# **Pentium® II Xeon™ Processor Specification Update**

Release Date: November 1998

Order Number: 243776-007

**Figure 1. An Example of Micro-controller Driven Thermal Management**

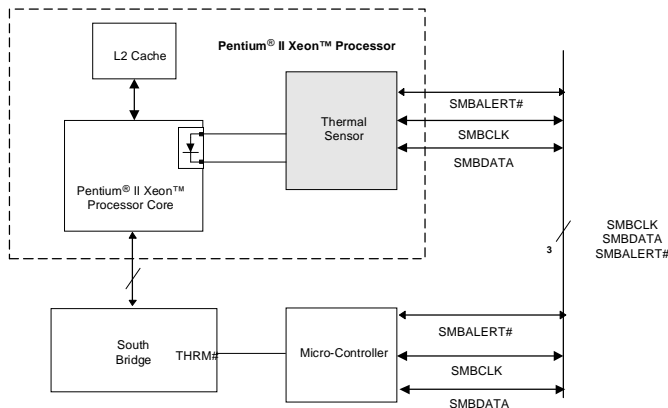
### D30. Thermal Sensor May Assert SMBALERT# Incorrectly

**PROBLEM:** The Pentium II Xeon processor has a thermal sensor that monitors the processor core's temperature. The thermal sensor asserts SMBALERT# if the processor temperature exceeds the temperature limits set in the Alarm Threshold Registers ( $T_{HIGH}$ ,  $T_{LOW}$ ). It also sets the corresponding Status Register bits to identify the cause of the interrupt. Figure 1 gives one example of the how the SMBALERT# signal could be used in a system.

Under the conditions described below, the thermal sensor incorrectly generates the SMBALERT# interrupt. *All* of the following conditions must be met to trigger a false interrupt:

**WORKAROUND:** Three different (mutually exclusive) workarounds are possible:

1. Before servicing an interrupt from the thermal sensor, read and compare the processor thermal reading with the threshold limits ( $T_{HIGH}$  or  $T_{LOW}$ ). Figures 2 and 3 provide basic flowcharts for the implementation of this workaround in an interrupt driven system.
2. If the firmware implemented polls the Status Register only, then before taking any action, re-read the temperature register and do a comparison with the alarm threshold limits ( $T_{HIGH}$  or  $T_{LOW}$ ) to determine if the value is actually still within the temperature window.
3. Use a temperature polling scheme to monitor the processor temperature.
